CERTIFICATE OF APPROPRIATENESS

Property: Tract 2, Block 276, Houston Heights Subdivision, City of Houston, Harris County, Texas. The site includes a 1-story 1,630 square foot residence situated on a 6,900 square foot (46'x150') lot. Approval for a two-story rear addition was granted at the February 2014 HAHC meeting.

Proposal: Alteration – Revision to a previously approved COA for work that exceeded the approved scope of work and that impacted the historic integrity of the existing structure. All original materials were to remain, as stipulated in the previously approved COA.

REPLACED TRIM / REMOVED SIDING
PHOTOS

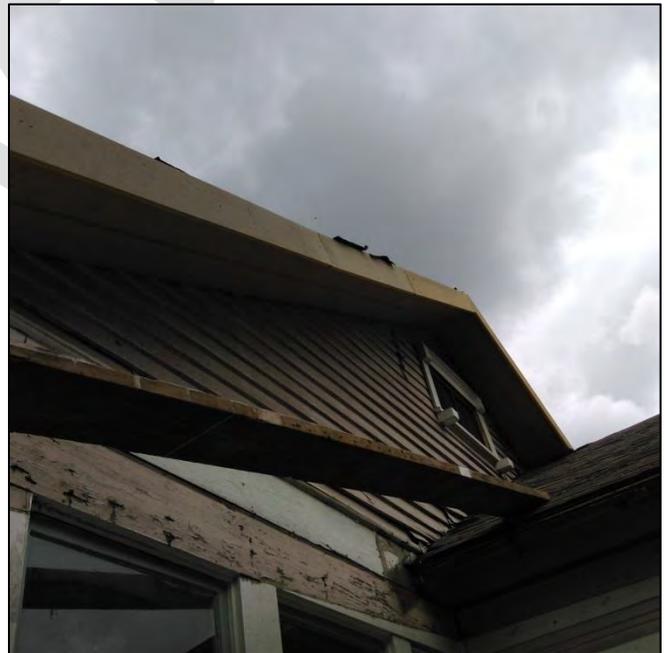
Exterior Materials: The original siding on the existing south elevation was removed without HAHC approval. The original trim was removed and replaced with textured cementitious material without HAHC approval. The original wood brackets were removed from the front elevation without HAHC approval.

The existing southern wall will be resided with new wood 117 siding to match existing 117 siding. The existing cementitious trim will be removed and replaced with wood trim to match existing. The removed brackets will be replaced with new wood brackets. See photos for more detail.

REMOVED BRACKETS / REPLACED TRIM

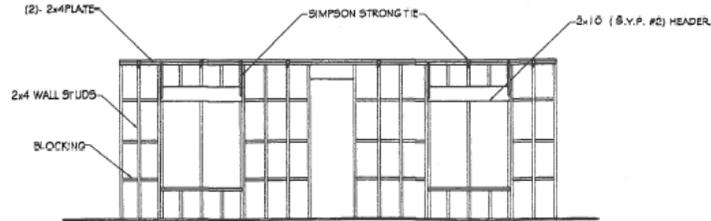
Front Elevation: Original wood trim was removed and replaced with textured cementitious trim without HAHC approval.
(East)

Existing cementitious trim will be removed and replaced with wood trim to match existing 117 siding. See photos for more detail.

SOUTH ELEVATION

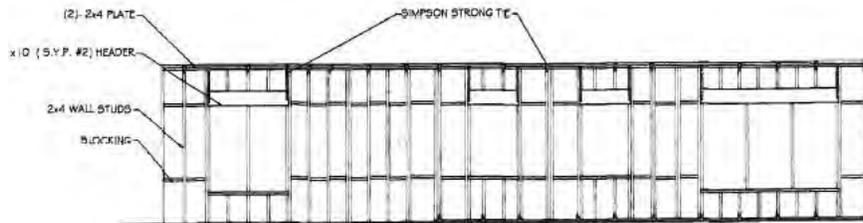
Side Elevation: The existing southern wall will be resided with new wood 117 siding to match existing 117 siding.
(South) The original windows on this elevation will also be reinstalled into the original locations. All trim removed and replaced with textured cementitious trim will be replaced with wood trim to match original. See photos for more detail.
